Access Compliance Report

Public Rights-of-Way

Intersection ID: 28304	Main Street: LANCASTER_HY	Cross Street: JOHNSTON RD	Location: SE
ADA ID: 6D5E54C240D9	Ramp Type: Perp	Initial Pass/Fail: Pass	Overall Compliance: No
Severity Score: 10.25			
Codes/Mitigation Info/Possible Solution		Field Measurements/Component Compliance

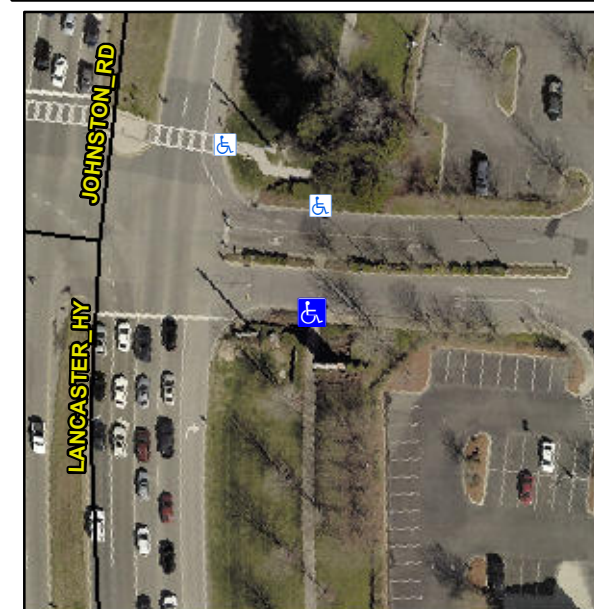
Not Found, R304.5.3, R304.2.2-Perp, R304.3.2-Para, R305

Compliance	Description	Data	Compliance	Description	Data
N/A	Ramp Length (in)	60.0	Yes	Ramp Slope (%)	7.2
Yes	Ramp Width (in)	71.0	No	Ramp XSlope (%)	2.7
N/A	Flare Type LT	Sloped	N/A	Flare Type RT	N/A
N/A	Flare Slope LT (%)	6.3	N/A	Flare Slope RT (%)	N/A
N/A	Flare Traversable LT?	Yes	N/A	Flare Traversable RT?	N/A
Yes	Landing Length (in)	71.0	No	DWS Provided?	No
Yes	Landing Width (in)	71.0	N/A	DWS Contrast?	No
No	Landing Slope (%)	4.4	N/A	DWS Length (in)	N/A
Yes	Landing X Slope (%)	1.8	N/A	DWS Full Width?	No
N/A	Landing Curb? (Y/N)	No	N/A	DWS Offset (in)	N/A
N/A	Shared Landing?	No			
Yes	Gutter Ponding?	No	Yes	Gutter Slope (%)	1.7
Yes	Gutter Lip Ht (in)	0.0	Yes	Gutter X Slope (%)	1.5
N/A	Painted X Walk1?	Yes	N/A	Painted X Walk2?	N/A
	X Walk 1 Direction	To NE		X Walk 2 Direction	N/A
N/A	X Walk 1 Width (in)	60.0	N/A	X Walk 2 Width (in)	N/A
	X Walk 1 Slope (%)	0.8		X Walk 2 Slope (%)	N/A
	X Walk 1 X Slope (%)	1.9		X Walk 2 X Slope (%)	N/A

Remove & Replace Entire Ramp.
